**SUBJECT: PALO VERDE NUCLEAR GENERATING STATION, UNITS 1, 2, AND 3 –  
STAFF ASSESSMENT OF RESPONSE TO 10 CFR 50.54(f) INFORMATION  
REQUEST – FLOOD-CAUSING MECHANISM REEVALUATION (CAC NOS.  
MF5546, MF5547 AND MF5548)**

STAFF ASSESSMENT BY THE OFFICE OF NUCLEAR REACTOR REGULATION

RELATED TO FLOODING HAZARD REEVALUATION REPORT

PALO VERDE NUCLEAR GENERATING STATION, UNITS 1, 2, AND 3

Figure 3.2-1. LIP Hyetograph for the PVNGS Site (APS, 2014, FHRR Figure 3-2)

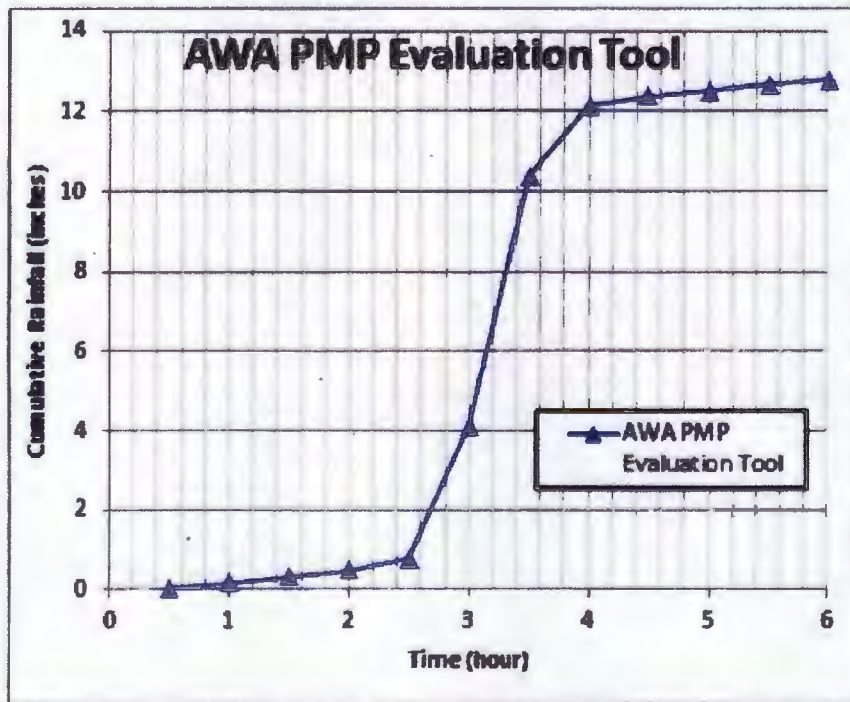
Arizona (AWA, 2013). As reported in the FHRR (APS, 2014), the AWA study relied on a 6-h, 1-mi<sup>2</sup> (3-km<sup>2</sup>) LIP event; according to that study, based on both updated meteorological record as well as numerical processing techniques, the site-specific PMP event was found to produce a lower cumulative rainfall depth of 12.8 in. (32.5 cm) over 6 hours. In deriving the LIP event used in the FHRR, the licensee assumed that peak rainfall intensity occurred at the midpoint of the thunderstorm event, as shown in Figure 3.2-1, with a maximum 10-min incremental rainfall depth of about 2.7 in. (6.9 cm), and a maximum 1-h rainfall depth of 10.7 in. (27.2 cm) (APS, 2014).

Figure 3.2-2. Flow Path Locations for Unit 1. Locations for Units 2 and 3 are similar.

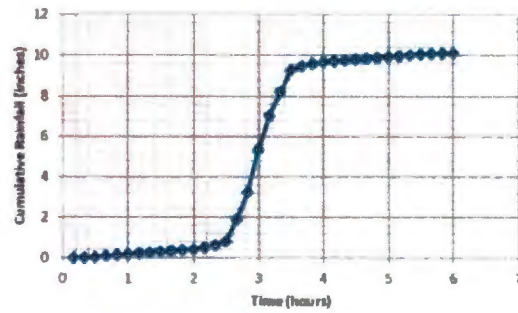
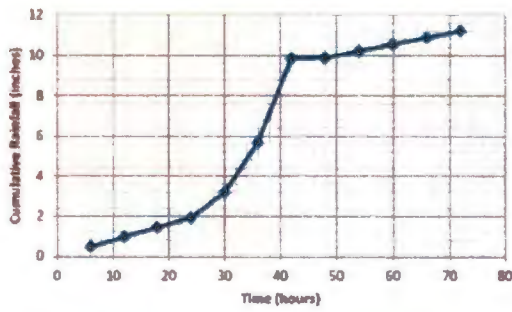
In evaluating the site drainage resulting from the LIP event, the licensee evaluated flood stages at 55 flow path locations common to each reactor unit (NRC, 2016b; see Figure 3.2-2) and reported the maximum estimated flood elevation corresponding to each location for each reactor unit (i.e., a total of 115 locations). Because of local topographic variations at each of the three units as built, local maxima of inundation depths were reported at different flow path locations for each of the three reactors.

Figure 3.2-3. FLO-2D Model Domain (in blue) for the LIP Flooding Evaluation. VBS shown in red, buildings in orange.

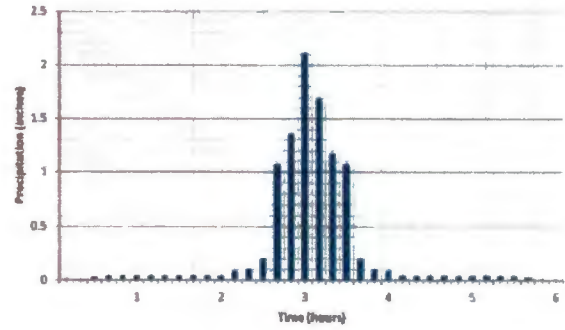
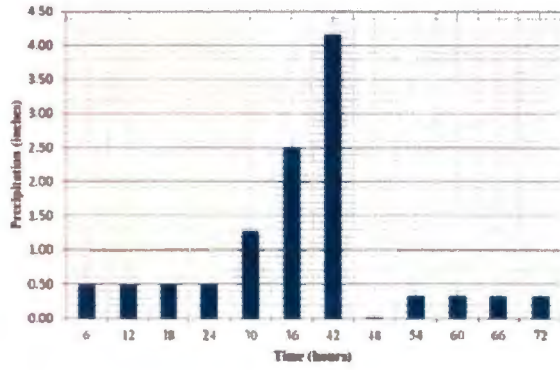
The licensee defined outflow cells along all boundaries of the FLO-2D modelling domain to allow surface water reaching any boundary location to flow out of the modelling domain. Most of the southern boundary of the computer model was located along the containment berm constituting the northern edge of the on-site evaporation ponds. The higher elevation of the berm, reported to extend 14 ft (4.3 m) above grade, limited the amount of outflow from those particular grid cell locations. Based on the topographic information provided by the licensee, the staff found the licensee's use of the outflow boundary conditions for the FLO-2D model appropriate. The FLO-2D model, which was reviewed by the NRC, had boundary and other key model features as shown in Figure 3.2-3.
